Service manual

RECORDERS N4450

Service Information

Fig. 2

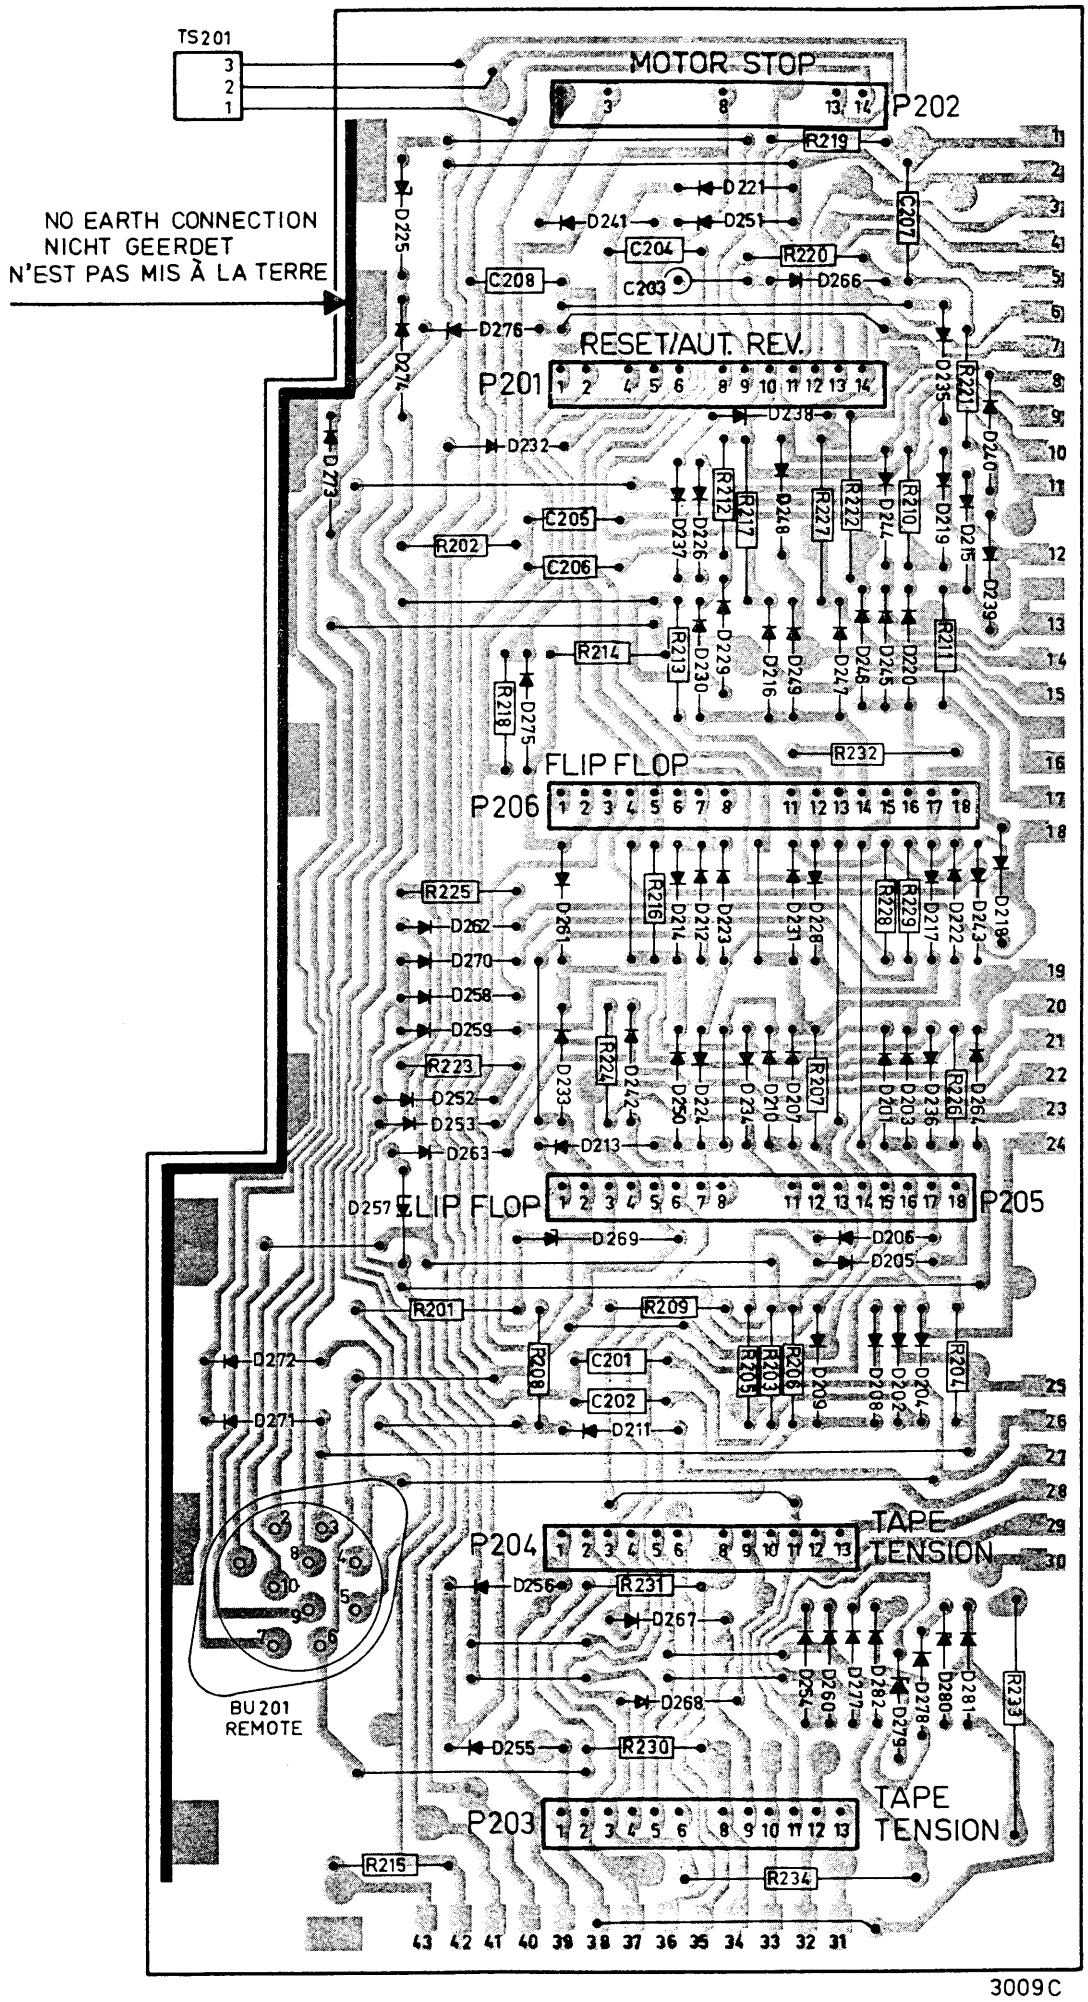
. In recorders, marked from WR09/304, resistor R202 (2.2 kΩ - 1/8 W ± 5 %) has been added on p.c. board 2 (see Fig. 2). Furthermore, the diodes D10 and D11 (BZX88/C3V3) on the RESET/AUTOMATIC REVERSE UNIT P201 have been replaced by BZX79/C4V7. This modification has been introduced because the recorder sometimes stopped at any moment when the remote control unit N6719 was used.

. In recorders, marked from WR09/323, the following modifications have been made on p.c. board 2 (see Fig. 2):
- the print tracks have been modified;
- the diodes D277, 278, 279, 280, 281, 282 and the resistors R232, 233, 234 are fitted to the component side.

SPEED CONTROL UNIT — N4418, N4450, N4510

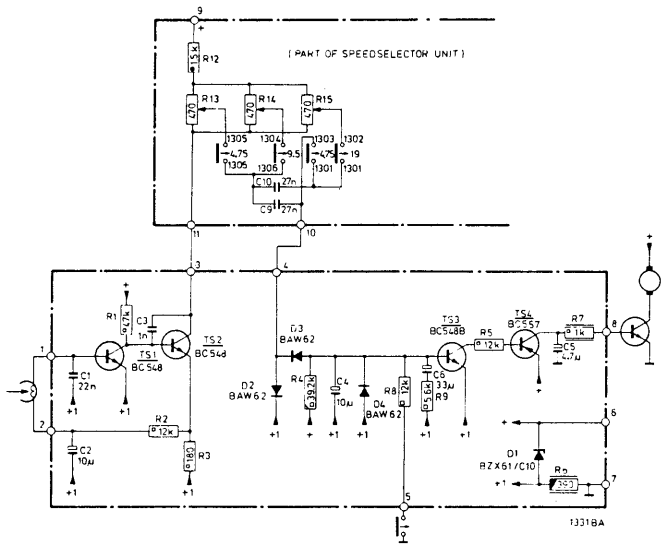
- D1 - BZX79/C10 has been replaced with BZX61/C10. Thus, the reliability has been improved.
  This modification has been made in recorders marked from WR07/317 (N4418), from WR09/316 (N4450), or from WR02/317 (N4510).
- D2,3 - BA217 have been replaced with BAW62; D4 - BA216 has been replaced with BAW62. Thus, the reliability has been improved. These modifications have been made in recorders marked from: WR07/304 (N4418), WR09/304 (N4450), WR02/304 (N4510)
- Some transistors have been replaced.

Original type	Replacement type
TS1,2 - BC148	BC548
TS3 - BC148	BC548B
TS4 - BC157	BC557

RESET-AUTOMATIC REVERSE UNIT — N4450

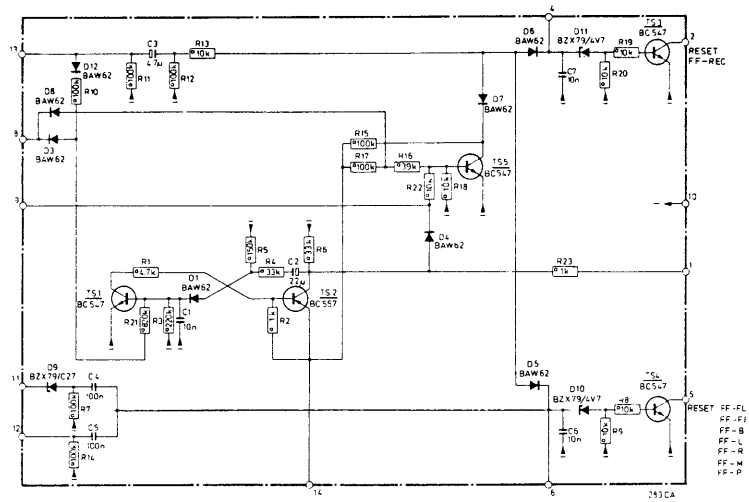
- D10, 11 - BZX88/C3V3 have been replaced with BZX79/C4V7. Thus, it has been avoided that the recorder suddenly stops when remote control N6719 is being used.
  This modification has been made in a limited number of recorders marked from WR09/240 and in all recorders marked from WR09/304.
- D9 - BZX79/C30 has been replaced with BZX79/C27. Thus, the switch clock will again function properly at too low a mains voltage.
  This modification has been made in recorders marked from WR09/333.
- D1,3,4,5,6,7,8,12 - BA217 have been replaced with BAW62. Thus, the reliability has been increased.
  This modification has been made in WR09/304.
- TS1,3,4 and 5 - BC147 have been replaced with BC547; TS2 - BC157 has been replaced with BC557.

POWER OUTPUT UNIT — N4450

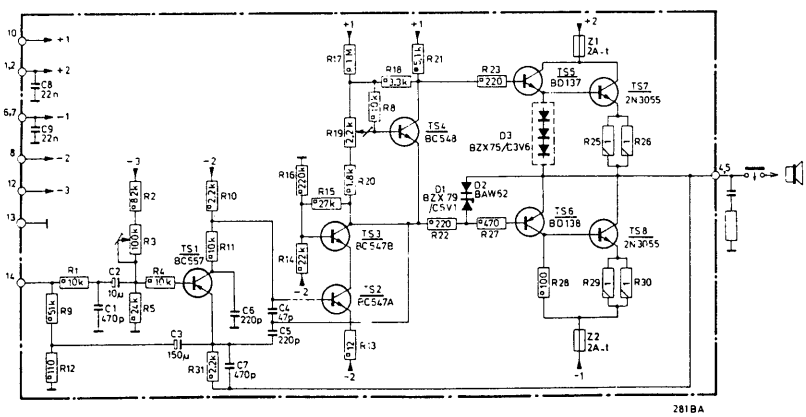
TS5,6 - 2N2219A, 2N2905A have been replaced with transistor pair BD137/138. This modification has been made in recorders marked from WR09/306.
R24 has been replaced with stabistor D3 - BZX75/C3V6. Thus, the fuses cannot fail.
This modification has been made in recorders marked from WR09/329.
D2 - BAX13 has been replaced with BAW62 because of a new supply programme.
The following transistors have been replaced.

Original type	Replacement type
TS1 - BC157	BC557
TS2 - BC147A	BC547A
TS3 - BC147B	BC547B
TS4 - BC148	BC548

TAPE TENSION UNIT — N4450

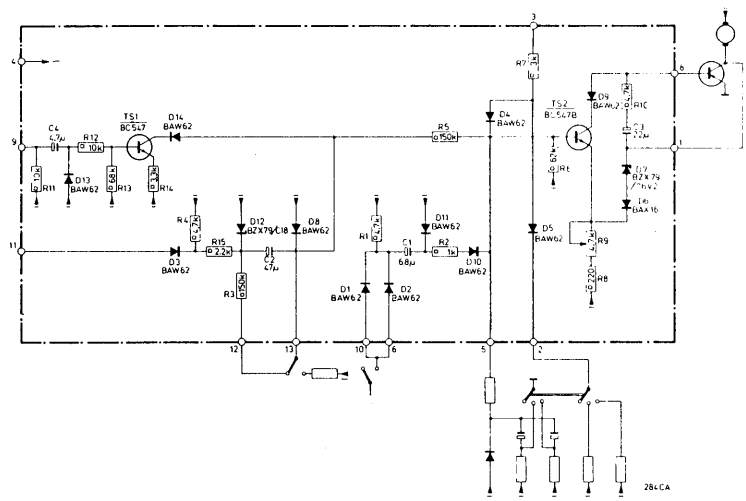
- D1,2,3,4,5,9,10,11,13,14 - BA217 have been replaced with BAW62 because of the changed range of diodes.
- TS1 - BC147 and TS2 - BC147B have been replaced with BC547 and BC547B respectively. Thus, fitting these transistors has been facilitated.
